PIC32MX1XX/2XX/5XX 64/100-pin Family Silicon Errata and Data Sheet Clarification

The PIC32MX1XX/2XX/5XX 64/100-pin family devices that you have received conform functionally to the current Device Data Sheet (DS60001290F), except for the anomalies described in this document.

17. Module: I/O Port - Initial Pin State

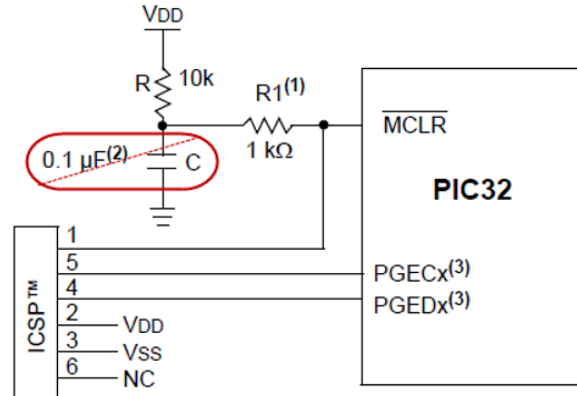
On power-up depending on the VDD ramp rate, the I/O pins can be in an active random output driving state if MCLR is active until a BOR event.

If, not using an external reset supervisor IC or equivalent, remove the MCLR capacitor as shown below, and retain the MCLR Pull-up resistor.

Work around 1:

Work around 2:

If using an external reset supervisor IC or equivalent, increase the value of the VCAP capacitor to $\geq 47 \mu\text{F}$ ceramic or solid tantalum capacitor with an ESR $\leq 1 \text{ ohm}$.
